REQUEST FOR INFORMATION

Project Name: KINDRED RESORT

Hardscapes Snowmelt Insulation

Kindred Resort @ Keystone
RFI-01245 Revision 0
response issued_04/26/2024

SHEET TITLE:
 DEMOLITION PLAN

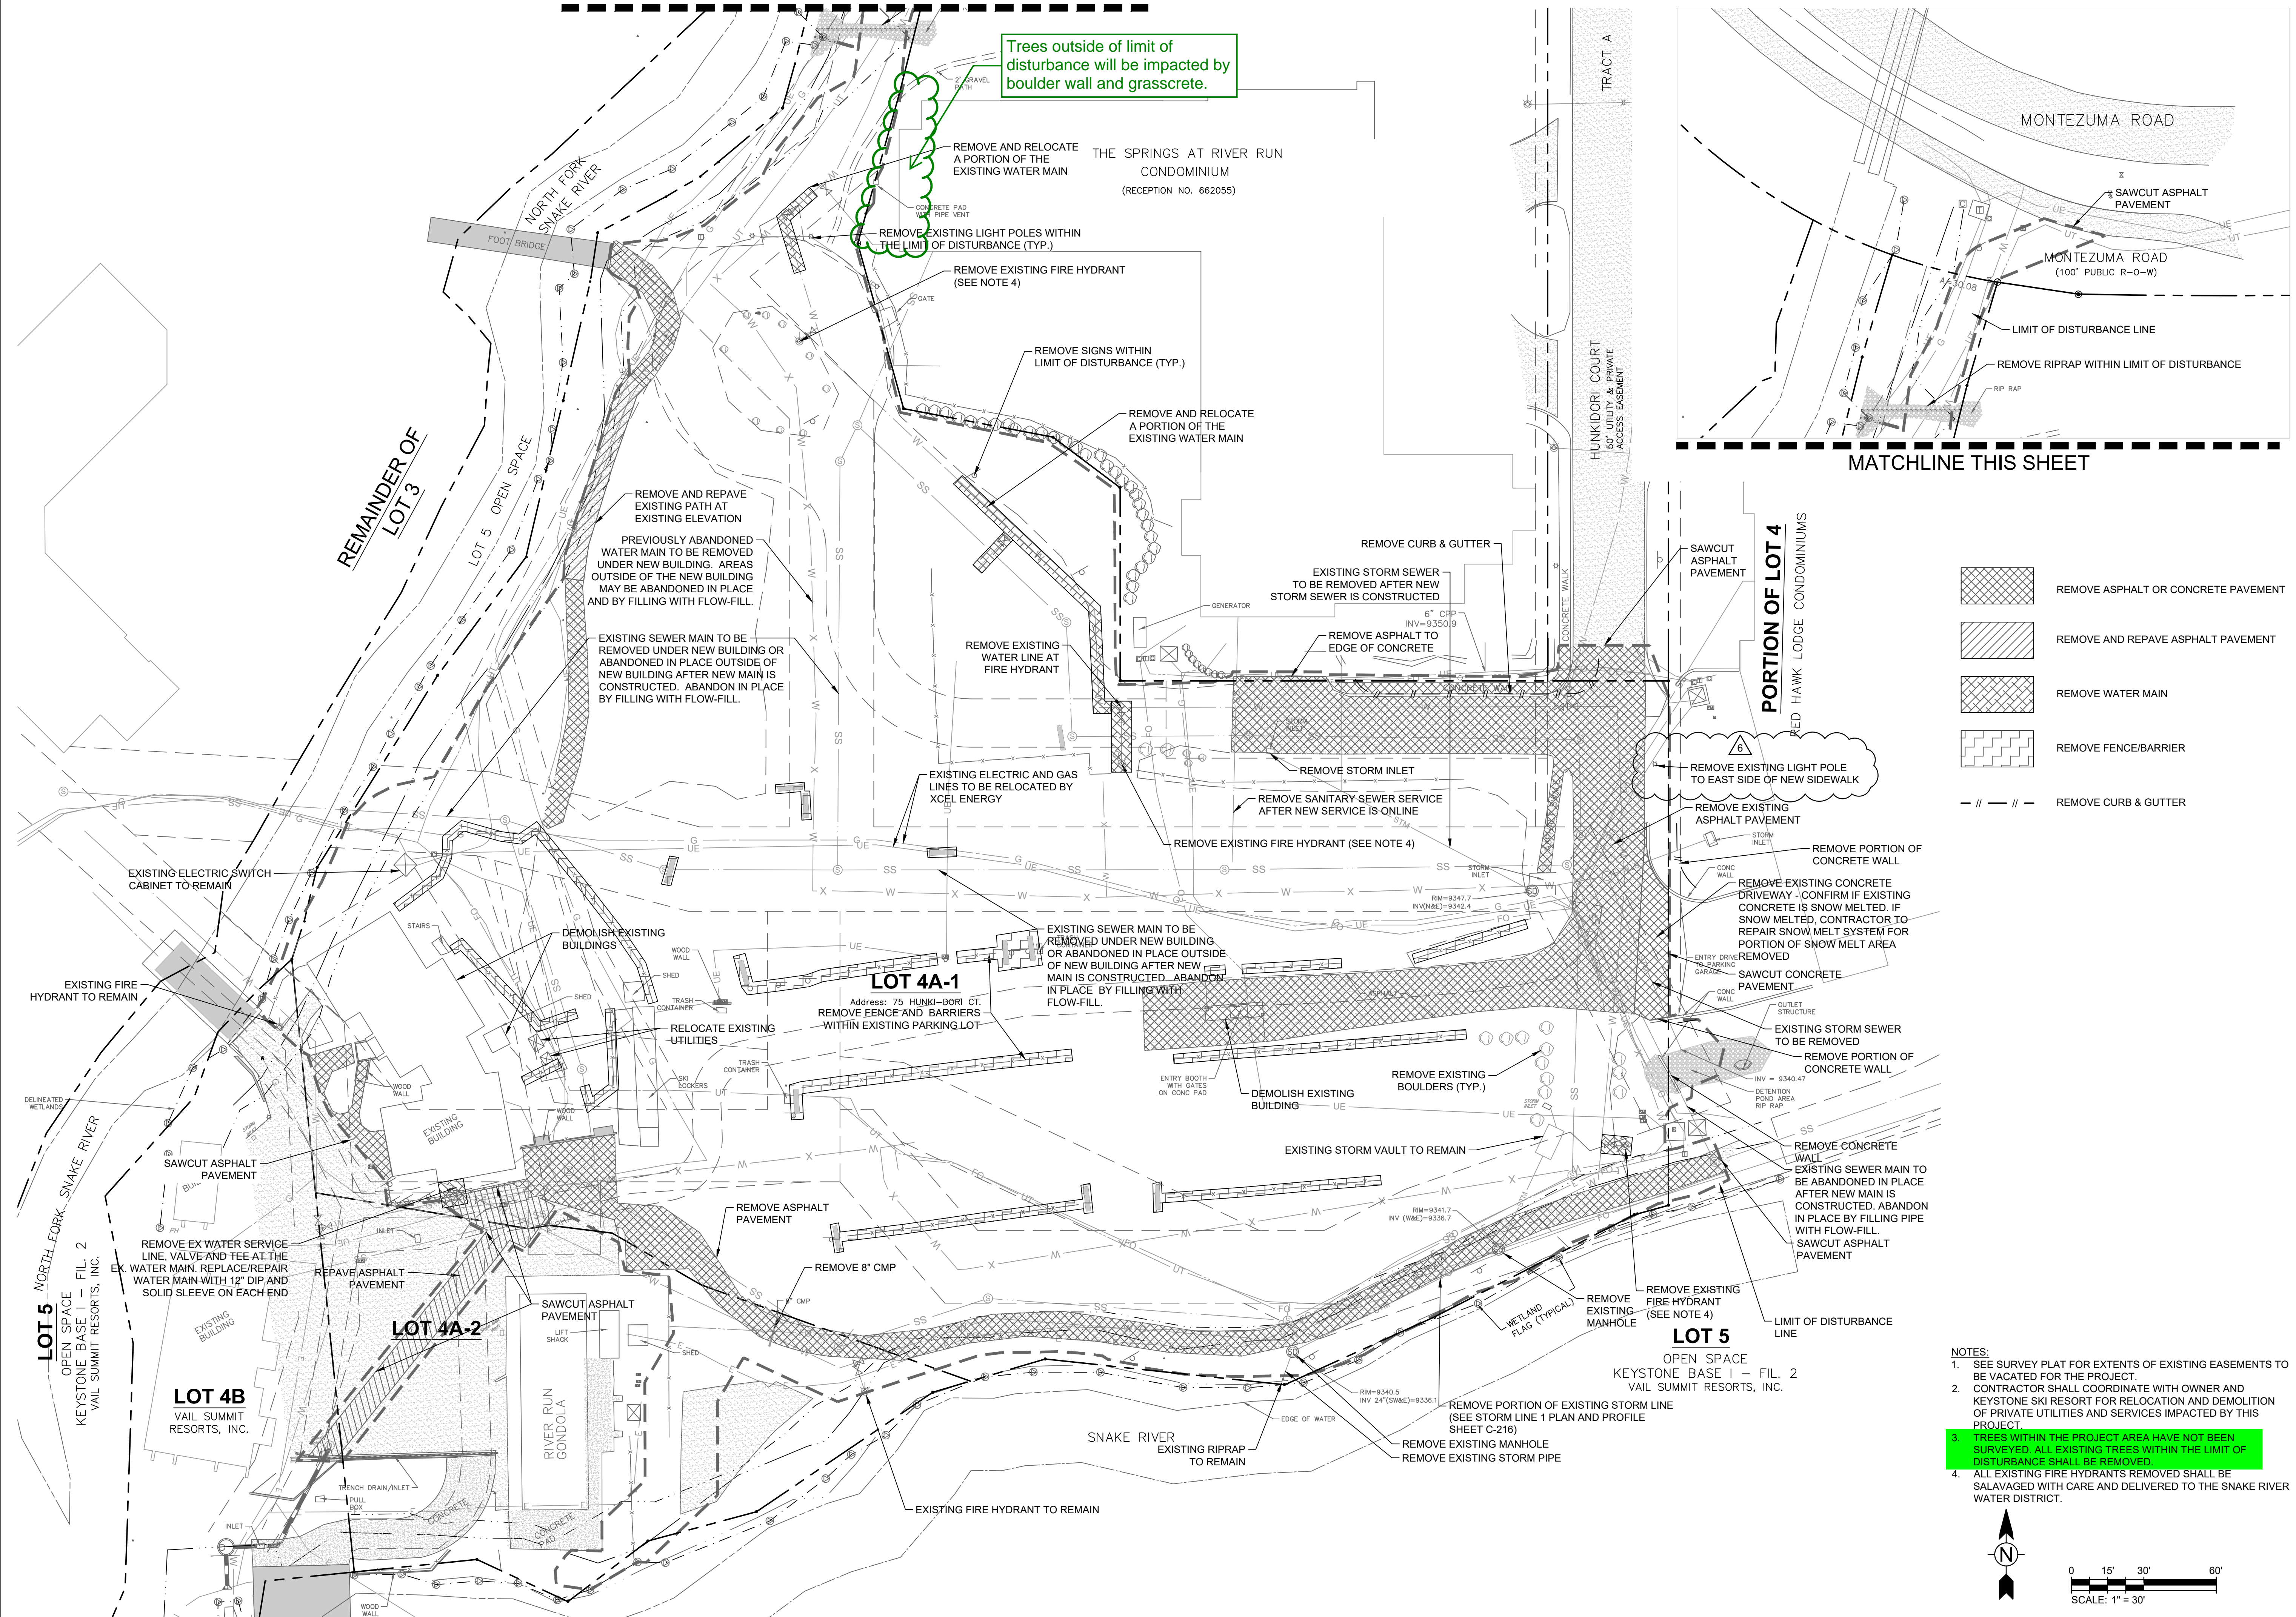
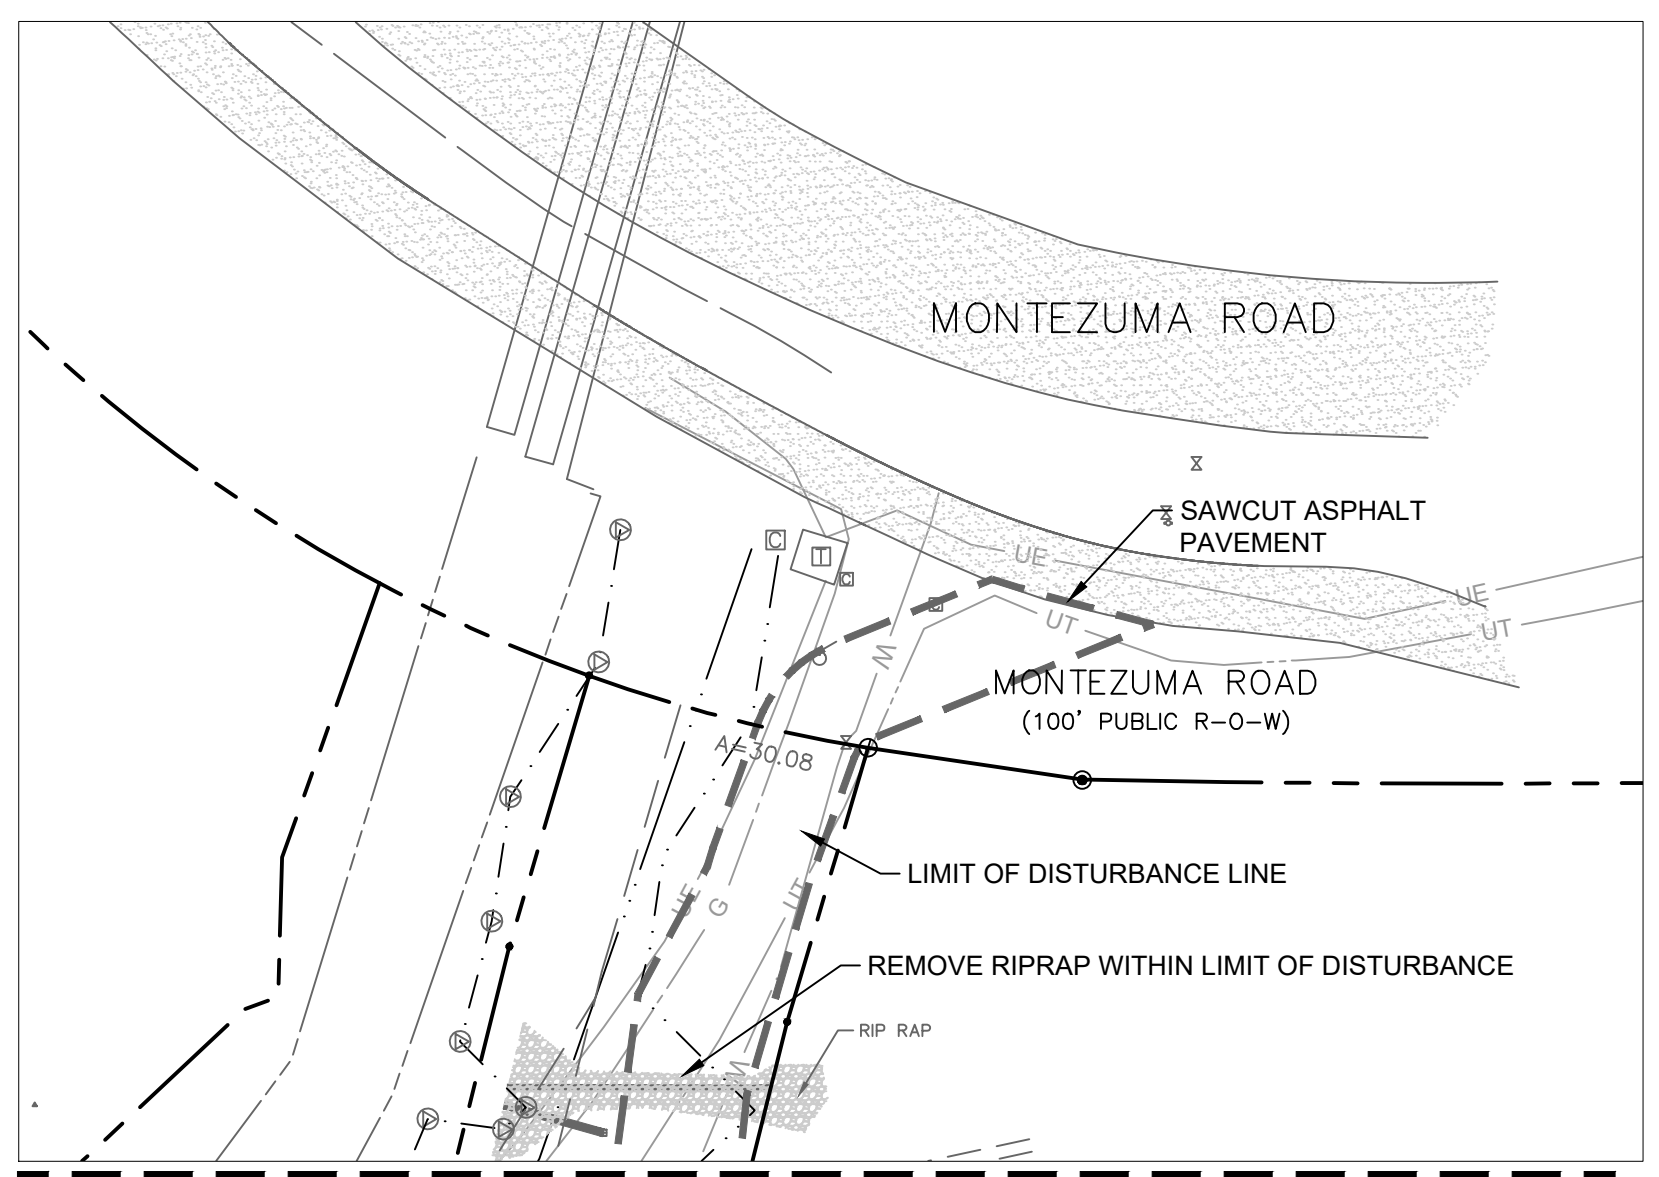
[Submitted: 8/27/2024 by Elliot Weiland, PCL Construction Services, Inc. Rev #0]
 Sheet C-102 requires the removal of all trees within the limit of disturbance. Sheet L-101 shows existing trees on the west side of the Springs building. There are (4) trees existing, as depicted in the attached, rather than the (2) trees as shown on L-101. All (4) of the existing trees' driplines conflict with the boulder wall and/or grasscrete, but the trees are outside of the limit of disturbance. The finish grade is about 4' lower than the existing grade at the trees. If the boulder wall is reconfigured as shown in red, the furthest south tree might not be impacted. Please confirm the (4) trees that are outside of the limit of disturbance in this area should be removed. Please confirm if the boulder wall should be reconfigured, and if so, please confirm the furthest south tree should remain.

Trees outside of limit of disturbance will be impacted by boulder wall and grasscrete.

Tetra Tech takes no exceptions in reconfiguring the boulder wall as show to save the 1 tree.
